NL-08-0300

**Vogtle Electric Generating Plant
Response to NRC Request for Additional Information Regarding License
Amendment Request to Revise Technical Specifications (TS) 3.3.2, "ESFAS
Instrumentation," and TS 3.5.4, "Refueling Water Storage Tank (RWST)"**

Response to NRC Request for Additional Information

Vogtle RWST Methodology

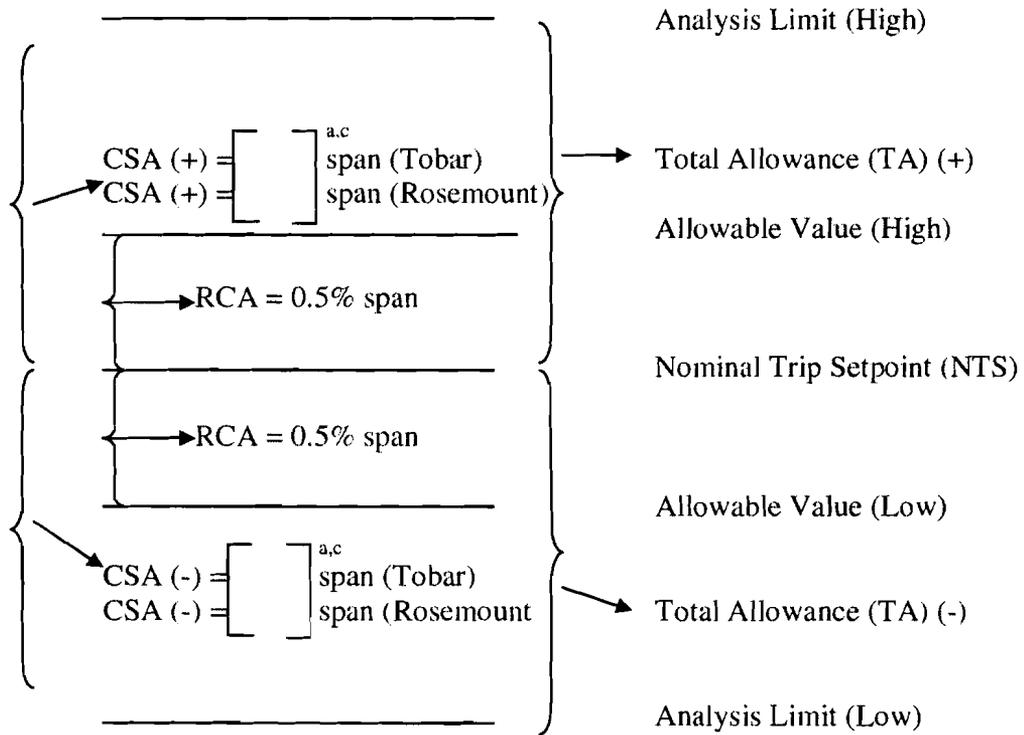
Discuss the methodology used to determine the overall instrument uncertainty for the RWST Level Low-Low trip function.

The basic uncertainty algorithm used to determine the overall instrument uncertainty for the RWST Level Low Low trip function is the square-root-sum-of-the squares (SRSS) of the applicable uncertainty terms. This is the same methodology as defined in WCAP-11269, Revision 1, "Westinghouse Setpoint Methodology for Protection Systems Vogtle Station," as modified for term dependencies as shown on the attached tables. This methodology combines the uncertainty components for a channel in an appropriate combination of those groups which are statistically and functionally independent. Those uncertainties which are not independent are conservatively treated by arithmetic summation and then combined via SRSS with the independent terms. This approach is consistent with NRC Regulatory Guide 1.105, Revision 3, "Setpoints for Safety-Related Instrumentation," and ISA Standard 67.04.01-2006, "Setpoints for Nuclear Safety-Related Instrumentation."

A calculation determined the bounding Channel Statistical Allowance (CSA) for this function. The Allowable Values (AVs) are determined by adding (or subtracting) the calibration accuracy, defined by the Rack Calibration Accuracy (RCA), to the Nominal Trip Setpoint (NTS) in the non-conservative direction(s) (i.e., toward or closer to the Analysis Limit(s) (AL)) for the application. The magnitude of the as left (calibration accuracy term) and the as found tolerances are the same and are specified in the station procedures.

Summary	
Parameter	Value
Channel Statistical Allowance (CSA)	[] ^{a,c}
Total Allowance (TA)	[]
Margin	[]
* Analysis Limit (High)	189.72 inches
* Allowable Value (High)	180.54 inches
* Nominal Trip Setpoint (NTS)	177.48 inches
* Allowable Value (Low)	174.42 inches
* Analysis Limit (Low)	165.24 inches
Span	612 inches

*** Reference point is 0% span (which is 36 inches from the bottom of the tank)**
